SERVICE BULLETIN

M-1264

2009-2010 TOURING MODEL FUEL TANK MOUNT SAFETY RECALL 0141

Figure 3. Fuel Tank Mounting Boss and Weld Notch

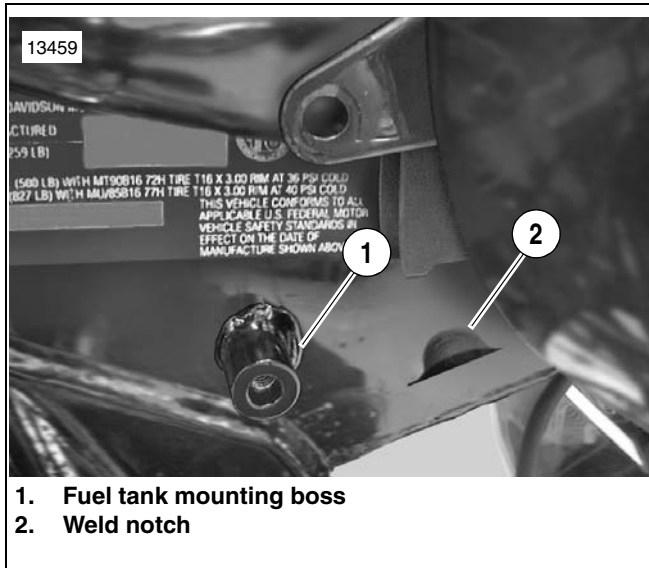
- See Figure 3. The tab on the rear of the brace should fit into the frame weld notch.
 - See Figure 4. The cutout of each brace should be positioned toward top.
6. See Figure 4. Install left and right braces onto front fuel tank mounting bosses.

Figure 6. Front Fuel Tank Fastener Boot Orientation

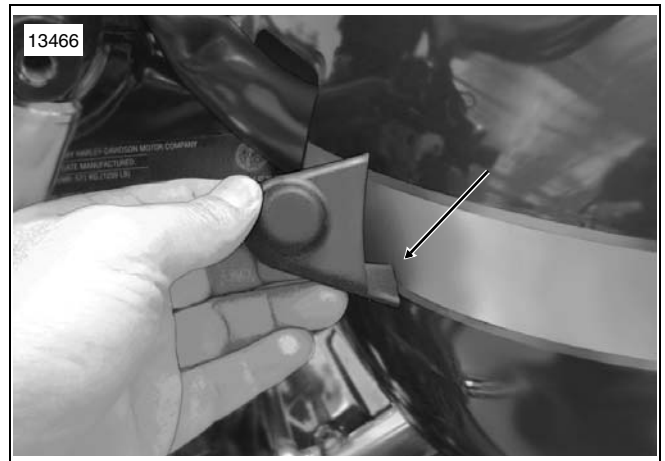
10. See Figure 6. Orient the fastener boot with tab facing downward.

Figure 7. Retaining Nub On Inside of Boot

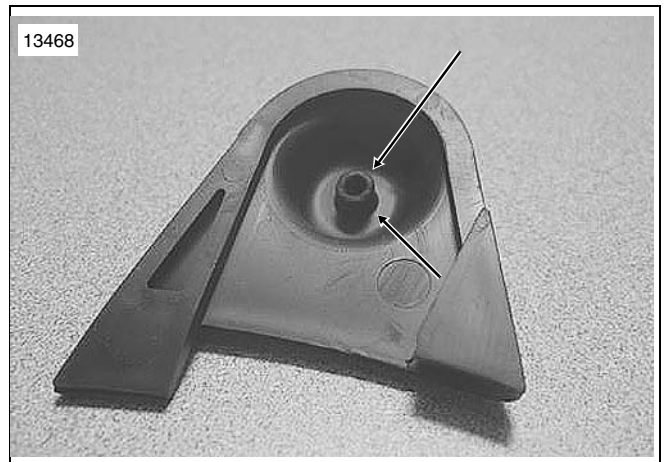
- See Figure 7. When installing the fuel tank fastener boot, always apply a drop of a quick setting adhesive to the retaining nub.
 - When installing the front fuel tank fastener boot, make sure that the nub on the inside of the boot is inserted into the depression in the head of the fastener for retention purposes.
11. See Figure 8. Install front fuel tank fastener boots by inserting the lower tab between the brace and the fuel tank, and flex the top lip over the fuel tank tab while aligning the nub with the bolt head, left and right.

Figure 9. Late 2010 Fuel Tank with Welded Tabs

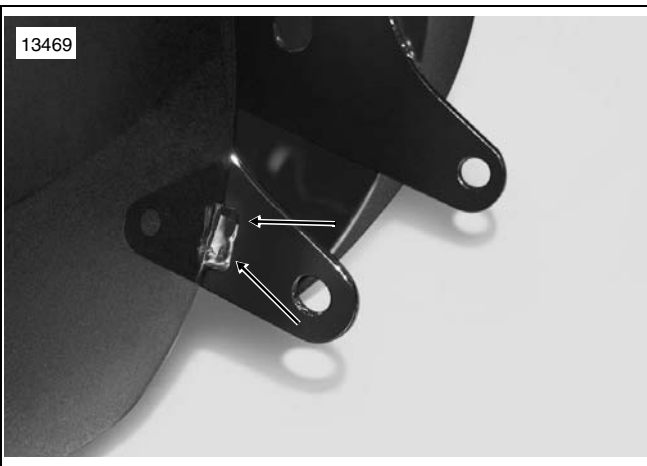
1. See Figure 9. When installing accessory or repair replacement fuel tanks on 2009/2010 Touring model motorcycles, always inspect new tank for weld on front tab. If weld is not present and fuel tank braces are not present, perform recall when installing the new fuel tank.
2. Refer to Table 1-4 for credit procedure.
